APPLICATION NO.	FILING DATE	FIRST NAMED INVENTOR	ATTORNEY DOCKET NO.	CONFIRMATION NO.
10/561,978	12/22/2005	Gerhard Winger	11201/20	1621
23838 7590 03/31/2008 KENYON & KENYON LLP 1500 K STREET N.W. SUITE 700 WASHINGTON, DC 20005				
EXAMINER ITALIANO, ROCCO				
ART UNIT		PAPER NUMBER		
4156				
MAIL DATE		DELIVERY MODE		
03/31/2008		PAPER

Office Action Summary

DETAILED ACTION

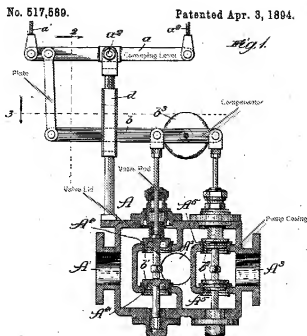
In regards to claim 12, Reichmann shows in the illustration in Fig. 1 valve rods (labeled by the examiner) which pierces the valves (b^1 and b^2), the pump casing (labeled by examiner) and the valve lid (labeled by examiner). It can be seen that the valves (b^1 and b^2) are connected to a lever (b), equivalent to that of a compensator as designated by the applicant, in which the lever (b) or compensator moveably connects the valve rods to conveying lever (a) by a plate (label by the examiner).
